DELAWARE RIVER BASIN,
ST. JONES RIVER, KENT COUNTY
DOVER DELAWARE.

SILVER LAKE DAM.

PHASE I INSPECTION REPORT.
NATIONAL DAM SAFETY PROGRAM.

DE 0031

1. 13 Dec 77. Upstream embankment slope behind overflow structure left abutment wall. Note sloughing of embankment, 4" remedial stone, and deteriorating concrete at freeze-thaw line.

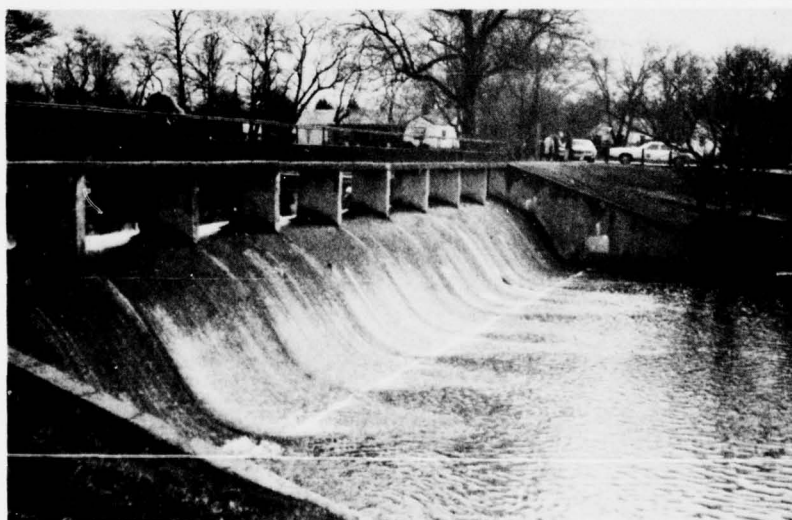
(3) Sloughing or erosion of embankment and abutment slopes: Sloughing was noted along the upstream embankment slope immediately left of the overflow structure. The sloughing appears to be the result of wave action; maintenance personnel attempted to alleviate the erosive action by placing 4-inch nominal ballast stone in the area. Stone appears unsatisfactory; see comment 6b (4) concerning the stone.

(2) Approach channel (concrete): The approach end of the left abutment overflow structure wall shows evidence of deteriorated concrete at the fluctuating freeze-thaw reservoir pool elevation. The right abutment wall approach end does not show this condition.

(1) Placement of suitably sized stone slope protection (rip-rap), including a bedding (filter) course along the eroded upstream and downstream areas of the dam.

5. 13 Dec 77. Close view of overflow structure left abutment wall showing diagonal cracking with minor leakage, looking southeast from walkway.

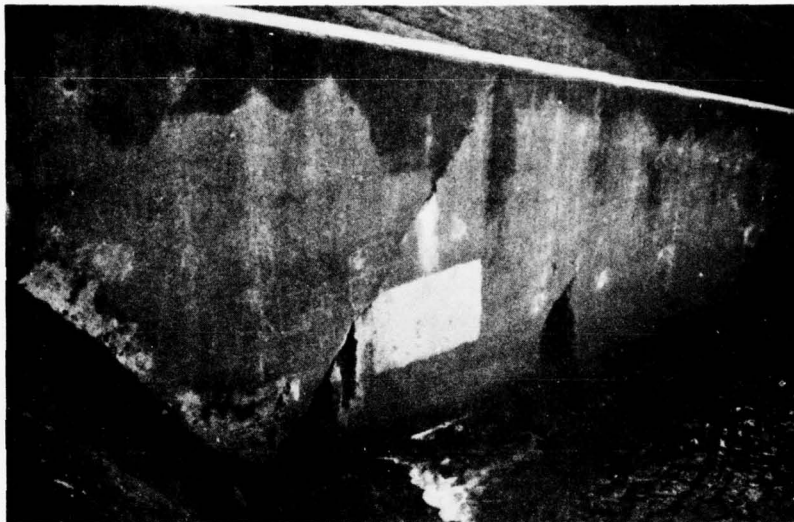
(3) Discharge channel (concrete): End of ogee of monoliths 3, 4, and 5 (from east) show signs of cavitation. Cavitation may be the result of misalignment between the ogee and runout slab monoliths; ogee end may be low or runout slab high. Both abutment walls contain full width, top to bottom cracks downstream of the crest. Both cracks indicate water seepage and partial calcite healing.

(4) Bridge and piers: A three-foot wide concrete walkway was constructed at top of dam elevation with support provided by vertical pedestals across the ogee weir crest. Several major longitudinal cracks were observed, 4 and 5 feet long, in the walkway above bay 5 (from left bank). Full length transverse cracks were observed at pedestal 6, and 10 feet left of pedestal 8. Generally, the underside of the walkway appeared badly spalled and deteriorated to the point of requiring replacement. The pedestals appeared cavitated at the spillway crest-pedestal flow line construction joint.

(1) Repair of concrete spalls and popouts in the overflow section of the spillway and at the upstream ends of the spillway abutment walls.

(2) Repair or replace deteriorated reinforced concrete foot bridge and piers.

7. 13 Dec 77. Spalled concrete at pedestal/ogee crest construction joint.

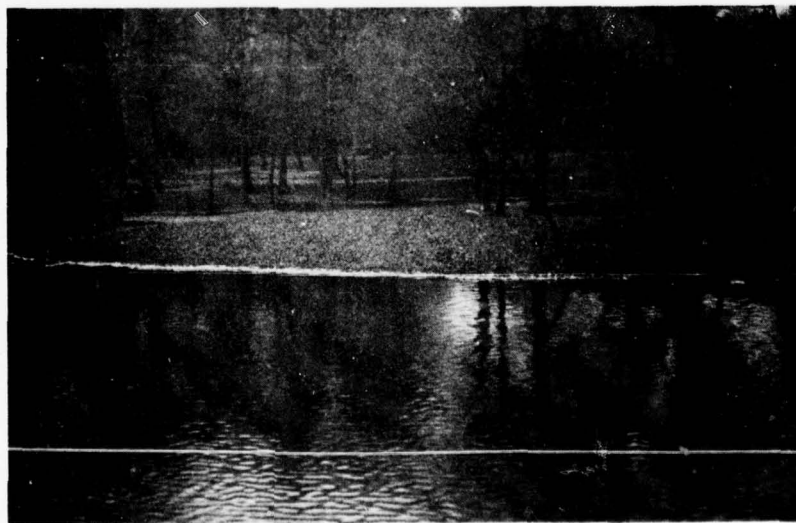
(3) Outlet channel: The outlet channel immediately downstream of the overflow structure makes an abrupt 45-degree turn towards the left bank. The turn has created an erosion problem along the downstream right bank and corrective measures were undertaken to alleviate the erosion by placing 4-inch nominal ballast stone in the undercut area. The ballast stone appears very poorly graded, undersized and is considered unsatisfactory to prevent erosion during high discharges.

LOAD CONDITION

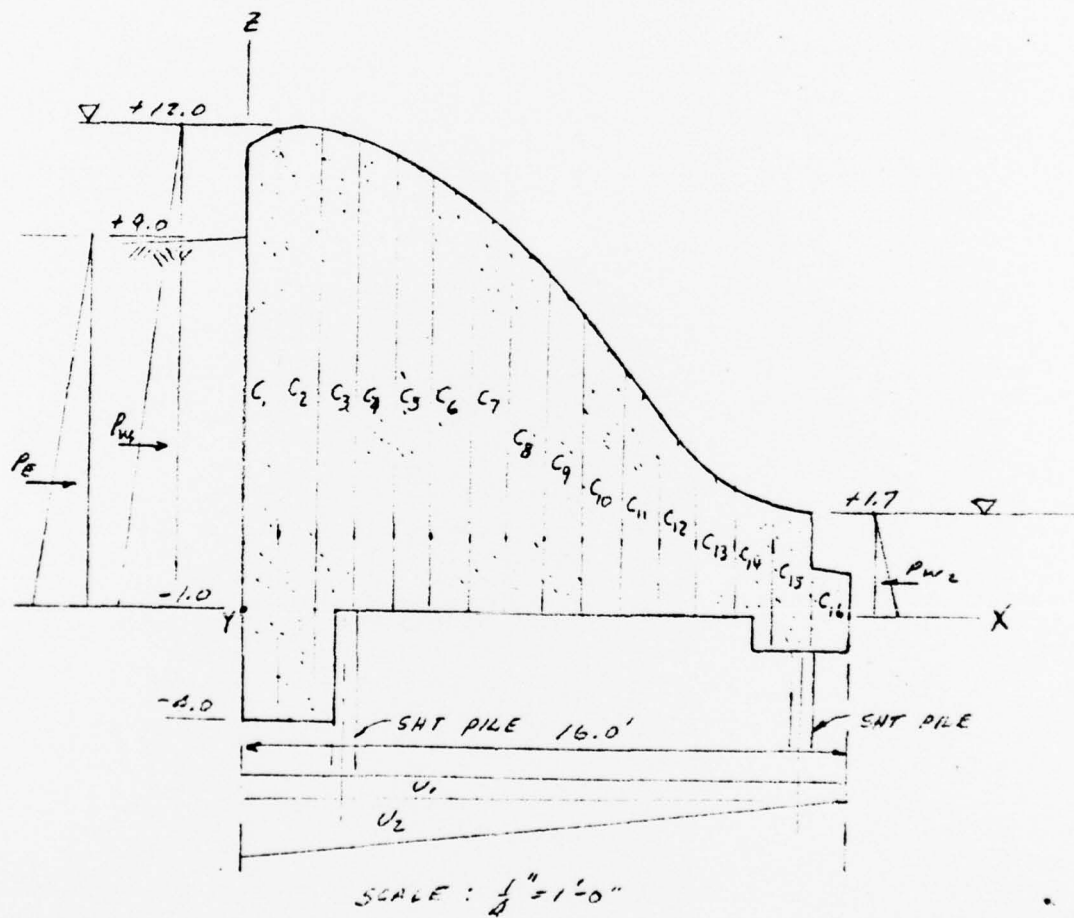
(2) Gravity Wall Stability: The gravity wall was evaluated for sliding and overturning in accordance with Corps of Engineers Manual for Gravity Wall Design and Corps of Engineers Technical Letter for Gravity Dam Design Stability. The factor of safety for sliding resistance was 1.5, which is somewhat lower than recommended, however, the evaluation was purposely made conservative by neglecting the sheet piling and upstream and downstream toes. The overturning analysis indicated that the resultant would act approximately one-third of the base distance from the upstream end. The analysis is contained in Appendix E.

Stability. The stability analysis was made for sliding resistance and overturning. In the interest of conservatism, the sheet piling was neglected thereby subjecting the wall to full uplift. The headwater elevation was assumed at ogee crest, elevation 14.4, and the ϕ angle at 33 degrees. The analysis shown hereafter, indicates that the gravity structure is stable from both a sliding and overturning stand point. The factor of safety for sliding was computed as 1.5 based on the conservative analysis and the overturning resultant was computed as occurring 7.24 feet from the upstream base end.
